RE: Data Response, Set 3A
San Francisco Electric Reliability Project (04-AFC-1)

**SAN FRANCISCO ELECTRIC
RELIABILITY PROJECT
(04-AFC-1)**

DATA RESPONSE, SET 3A
(Responses to Data Requests: 161-193)

FIGURE CR-178
PREHISTORIC SHORELINE
 SAN FRANCISCO ELECTRIC RELIABILITY PROJECT
 SUPPLEMENT A

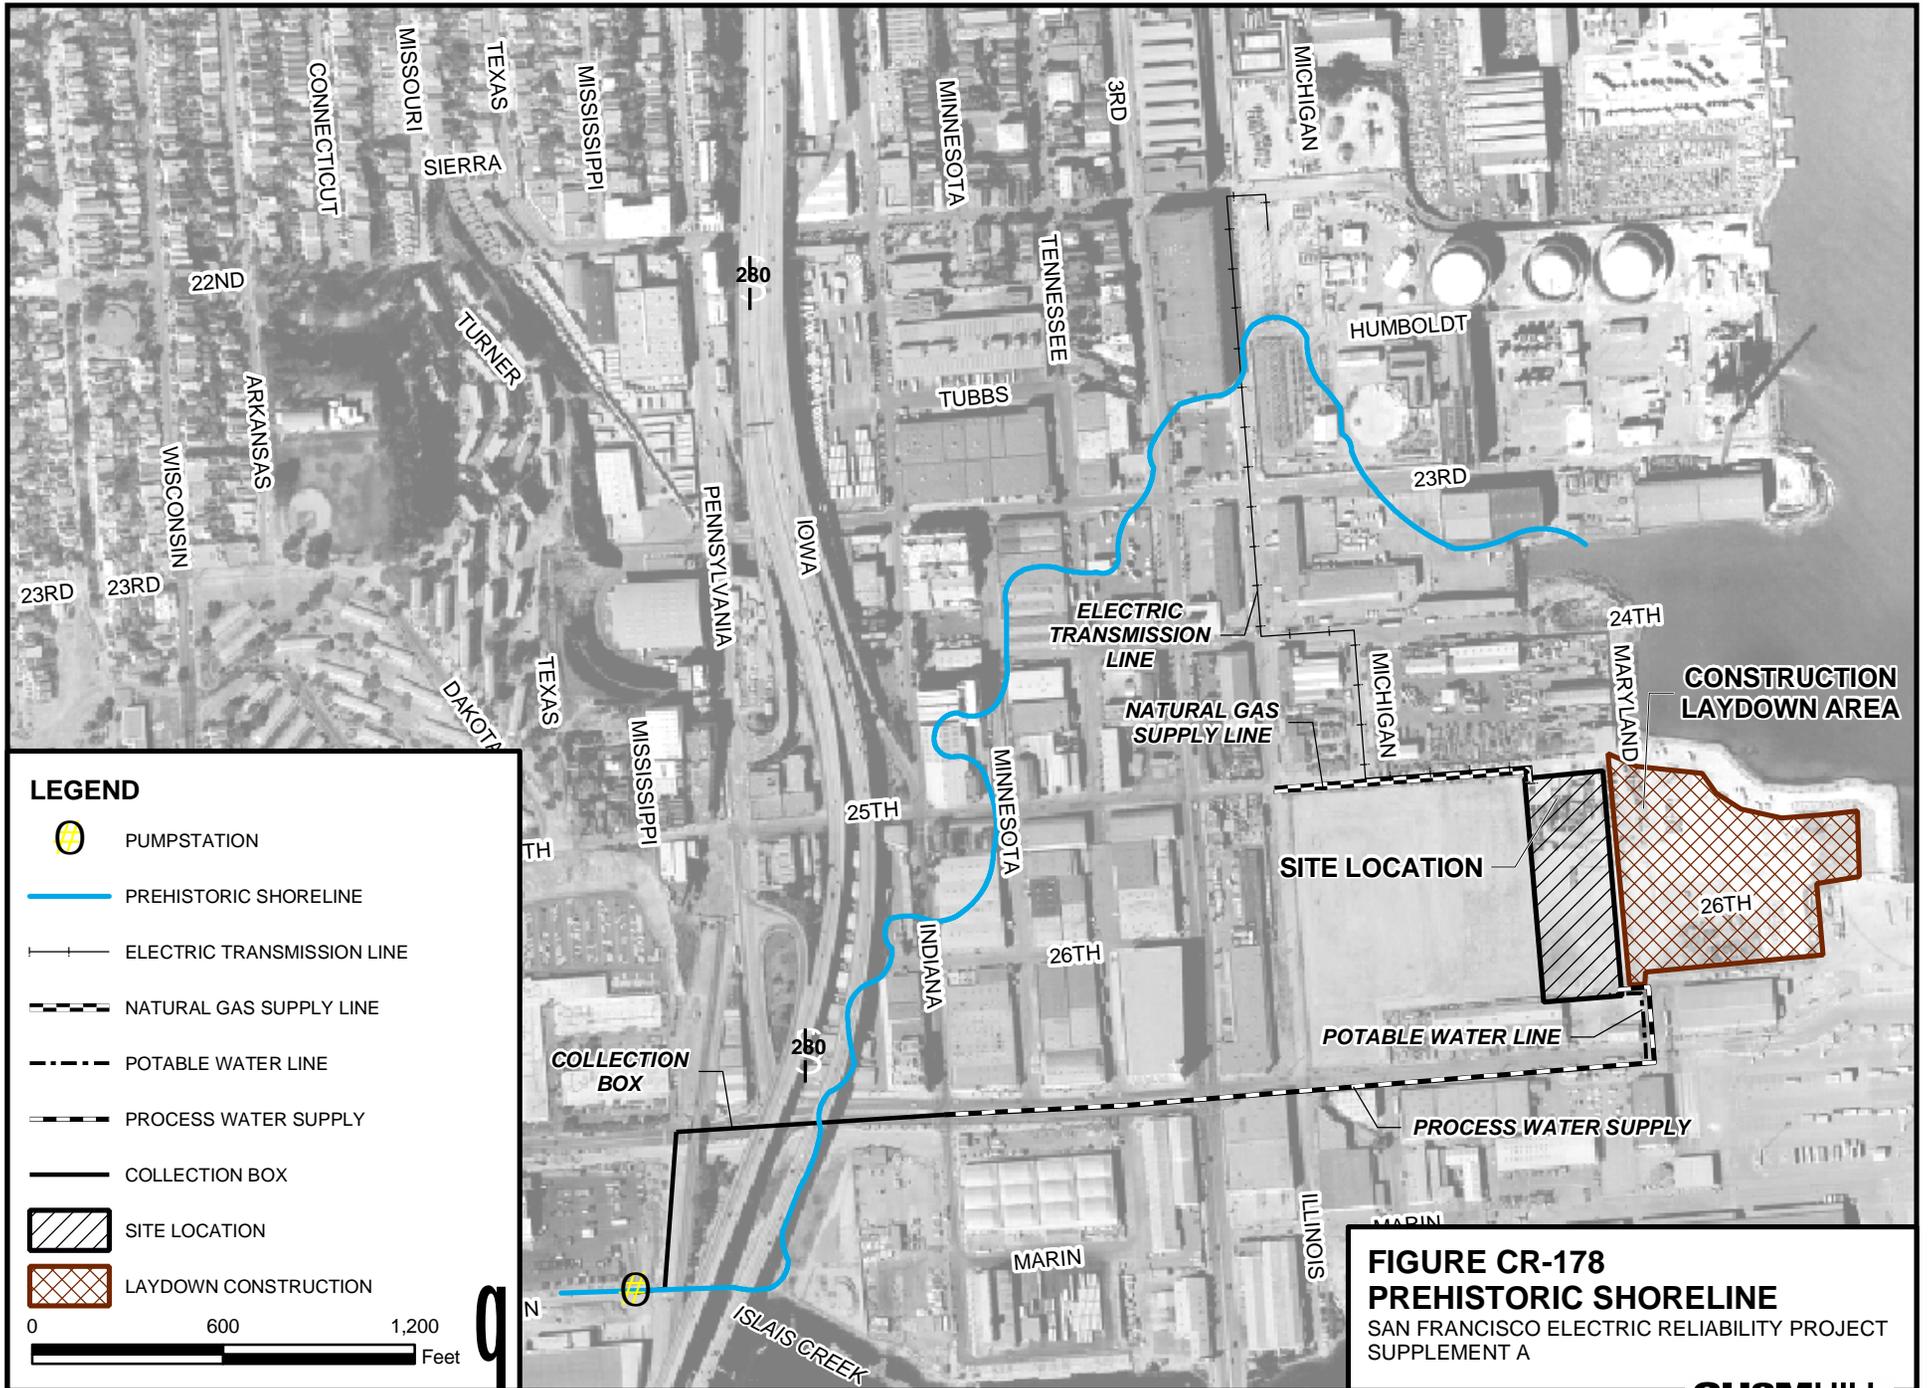
178. Using the maps cited in the Cultural Resources “References” (Section 8.3.9) and any additional relevant sources, please provide a map delineating the earliest known shoreline in the area of Marin, Mississippi, and Cesar Chavez Streets, and Interstate 280.

Response: Figure CR-178 depicts the earliest known shoreline in the area of Marin, Mississippi, and Cesar Chavez Streets, and Interstate 280.

FIGURE WS-185A
 SFERP
 SAN FRANCISCO, CALIFORNIA
 MUNI SITE
 PRE-DEVELOPED DRAINAGE AREA PLAN

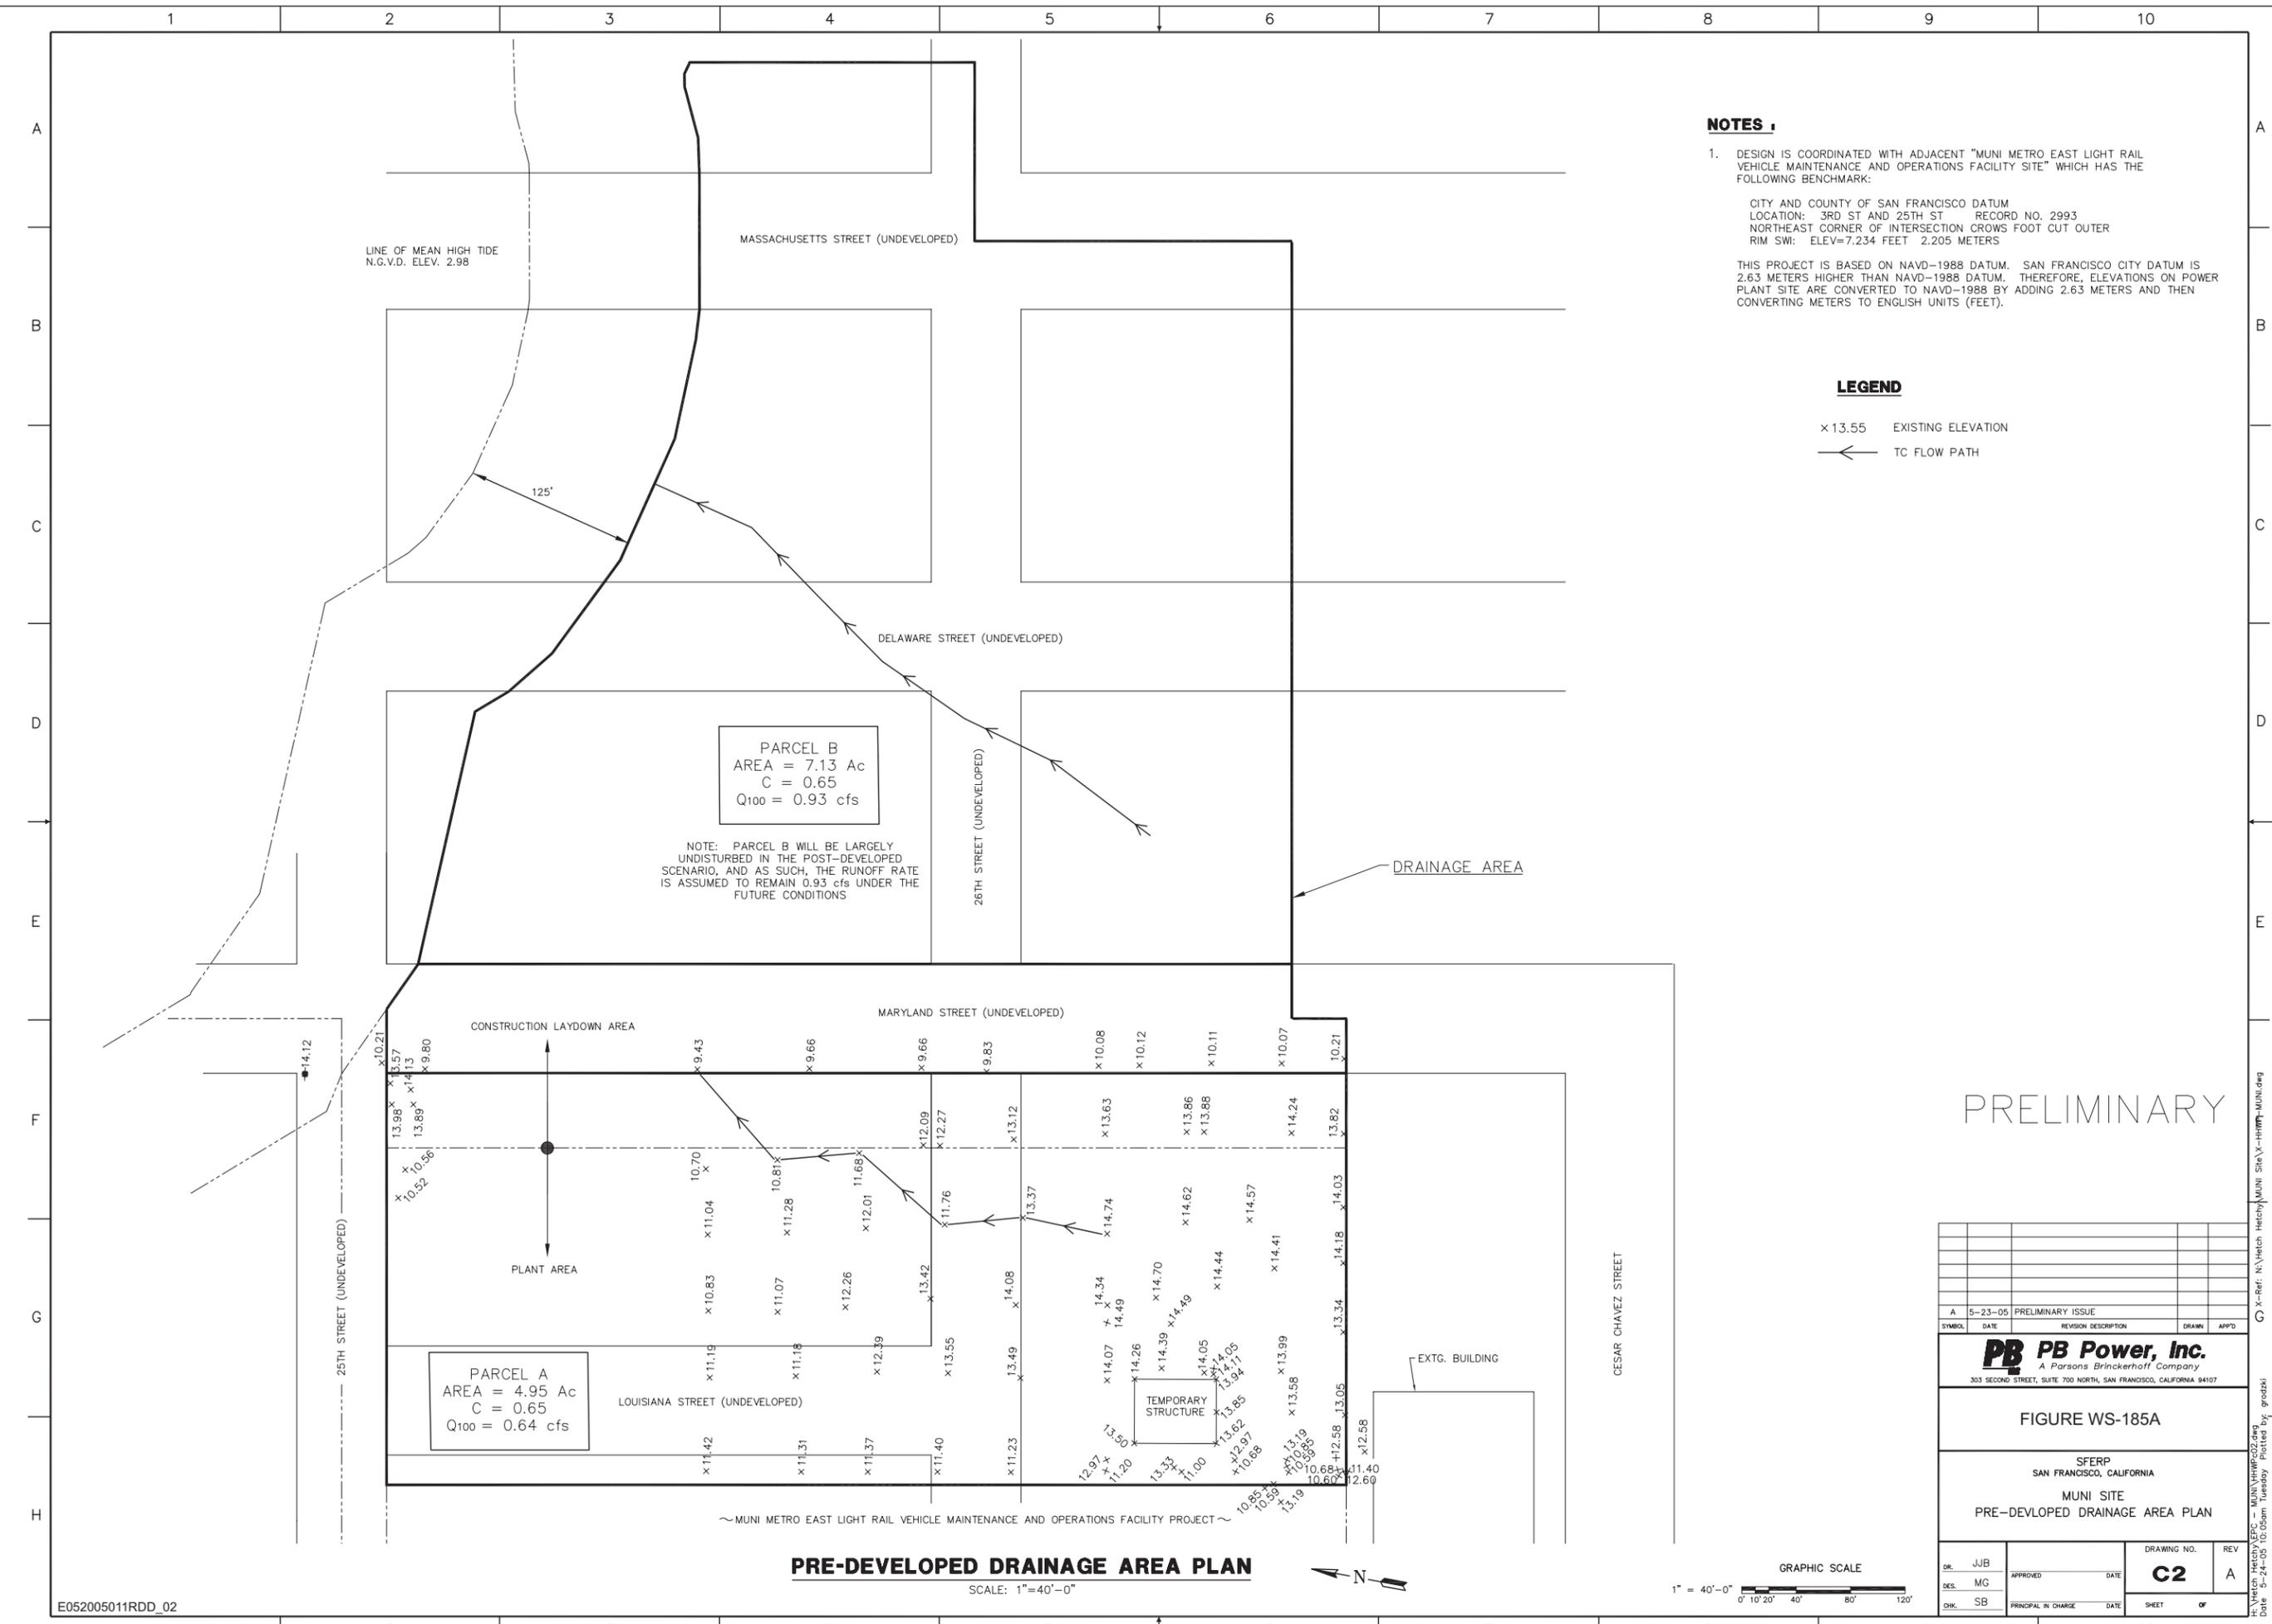
185. Provide the pre- and post-construction runoff and drainage patterns for the 100-year frequency and 24-hour runoff event.

- a) a site map at 1"=100' or less that depicts existing and proposed topography (contours) with labeled elevations, site perimeter, existing and proposed buildings, drainage patterns to stormwater inlets, and on-site and off-site soil stockpile areas;

Response: The pre- and post-construction runoff and drainage patterns are shown on the attached Figures WS-185A and WS-185B.

Response: See Figures WS-185A and 185B.
